SUBJECT : Hyundai ImageQuest Co., Ltd.
FCC ID: PJIL19C0D072
Class II Permissive Change
Orig. Grant Date: September 16, 2004

Transmitted herewith, on behalf of Hyundai ImageQuest Co., Ltd. is an application for a Class II Permissive Change Certification of the following 19-inch LCD Monitor:

FCC ID : PJIL19C0D072
Model No. / Type No.: L90D+ / L19C0D072

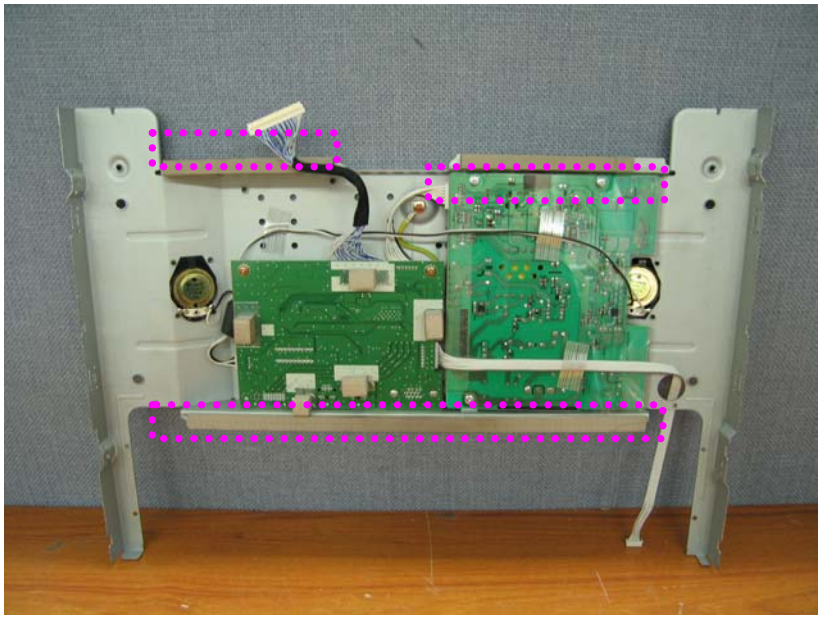
1. Attach a gasket to internal frame

2.Apply a ferrite Core to the Speaker Cable

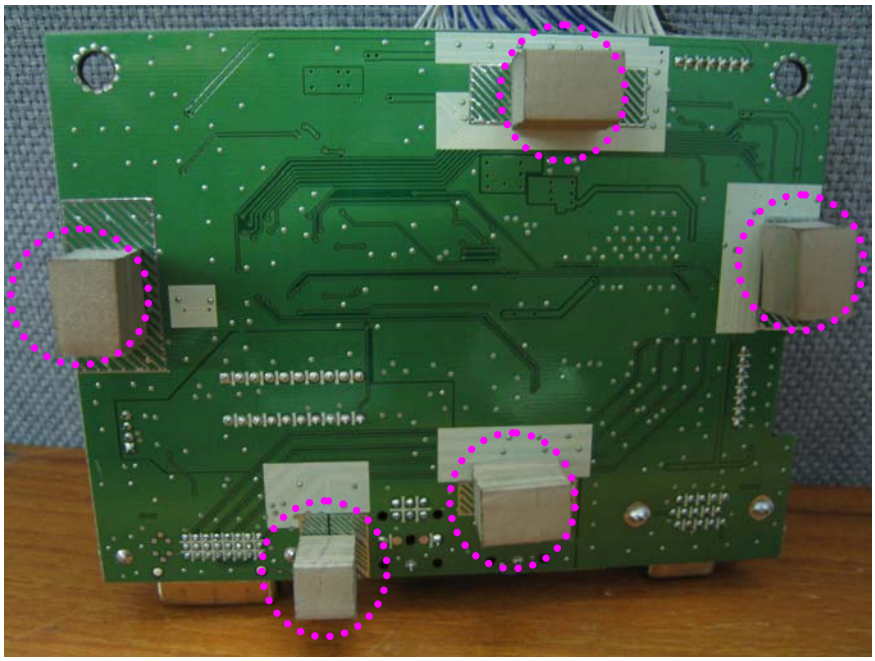
3. Attach a gasket to main board

4. Apply a strip of aluminum tape on the conductive strip to the frame.
